**NOTICE OF FINAL
FINDINGS, CONCLUSIONS AND DECISION
OF THE CITY OF PORTLAND HISTORIC LANDMARKS COMMISSION
ON AN
APPEALED ADMINISTRATIVE DECISION
(Type II Process)**

**CASE FILE: LU 07-180515 HDZ, Irvington Squire
LOCATION: 1510 NE HANCOCK**

Proposal: The applicant requests historic design review approval to construct a new 5-story condominium building [14 units total] on a 10,000 SF lot at the corner of NE 15th Avenue and NE Hancock Street in the Historic Irvington Conservation District. The building height is approximately 64 feet to the top of the rooftop mechanical screen and 60'-8" to the top of parapet of the attic penthouse. *[Maximum height allowed for this site under current regulations is 75'.]* Sixteen parking spaces are proposed on the first floor with vehicle access from NE Hancock. The ground level also includes lobby/parlor area at the corner and building services and trash/utilities access facing NE 15th Avenue.

First Floor Plan
A-1001

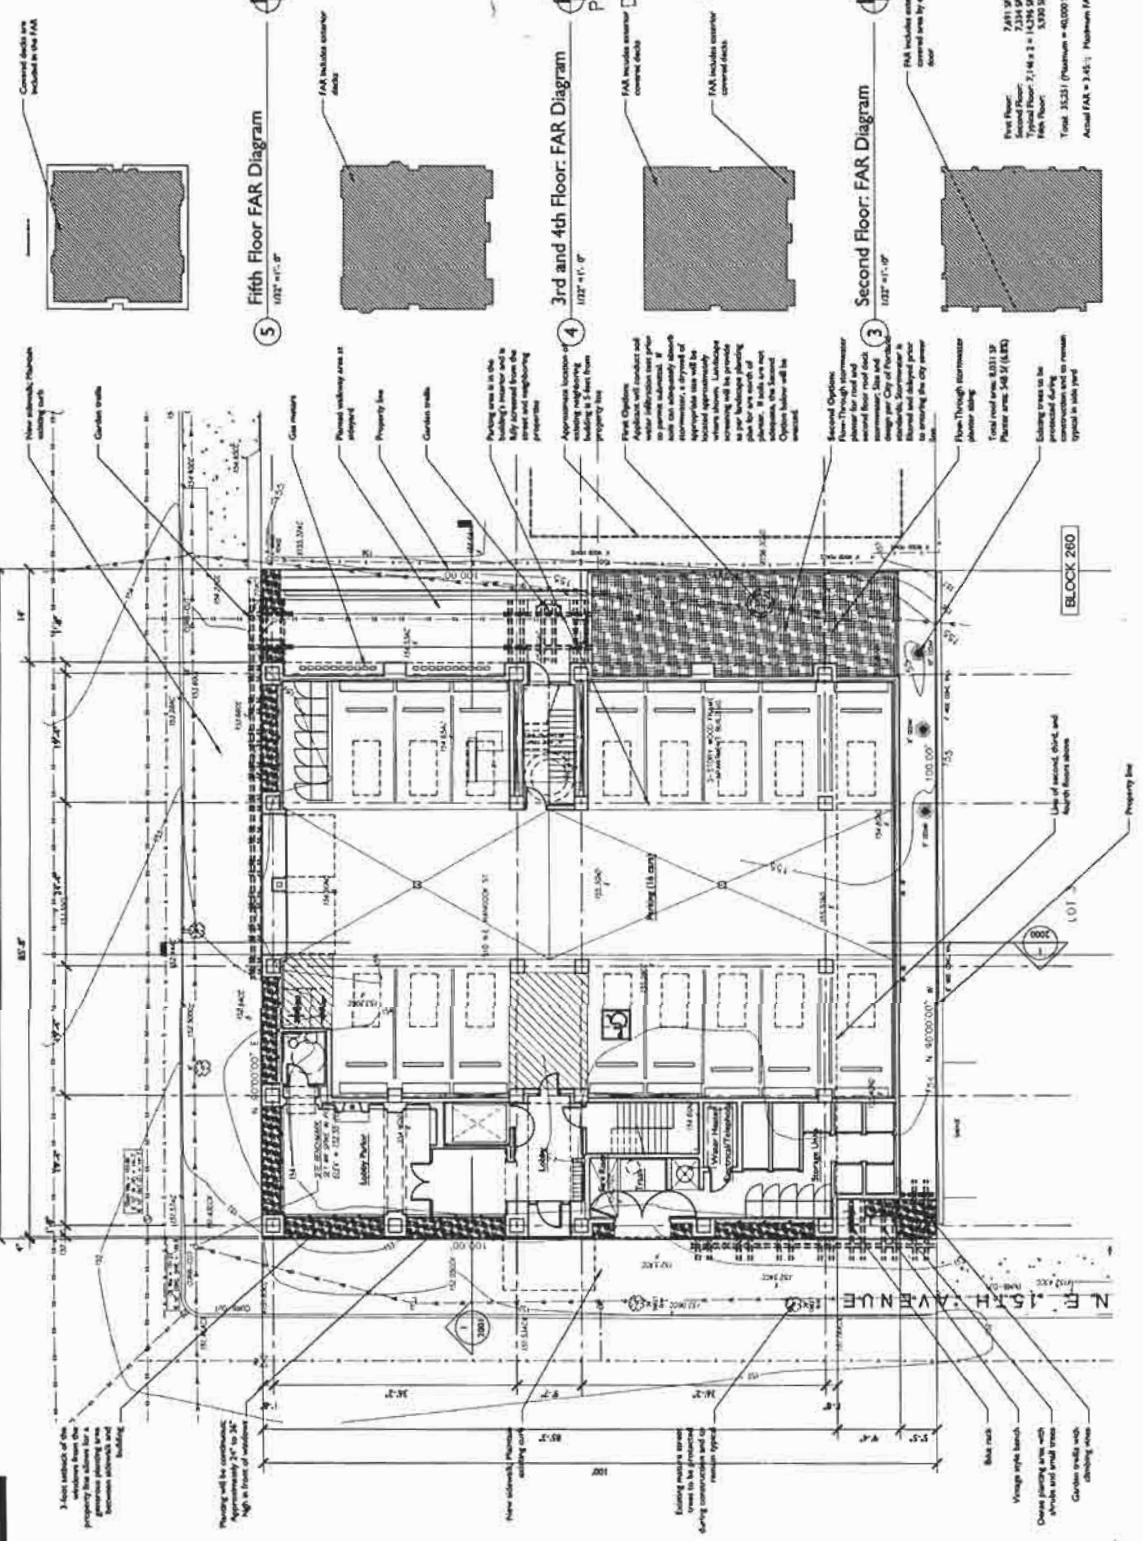
4. The applicant currently shows a stormwater planter on the eastern edge of the property. However, it is not clear what the intent of this planter is (i.e. infiltration or flow-through only); if there is adequate space for the planter; or if it meets the Destination/Disposal Hierarchy (see above comment). BES therefore concurs with BDS SD that a stormwater report which adequately addresses the Hierarchy (including infiltration feasibility), facility sizing, and all other applicable requirements of the SWMM should be submitted prior to BES recommendation of approval of this review.

“BES has reviewed the First Floor Plan (Sheet A-1001), revised 06/26/08, emailed by the applicant on 7/3/05. The revised plan is showing two options for stormwater treatment/disposal: the first option is a drywell in the eastern setback between the proposed structure and the eastern lot line, and the second option is a flow-through planter with overflow to the public sewer. There appears to be adequate area for the drywell to meet setback requirements from proposed/existing structures (10’), and to lot lines (5’). In addition, the planter appears to provide adequate treatment area per 2004 Stormwater Management Manual (SWMM). Findings can be made that the proposed design can accommodate stormwater facilities that meet the SWMM. At the time of building permit review, the applicant will be required to submit infiltration testing to confirm whether the drywell will be feasible. If feasible, the drywell will be required to meet the SWMM’s Hierarchy for stormwater discharge.

Therefore, based on the revised site plan and verbal communication with BDS Site Development, BES has no further objections to the proposal.”
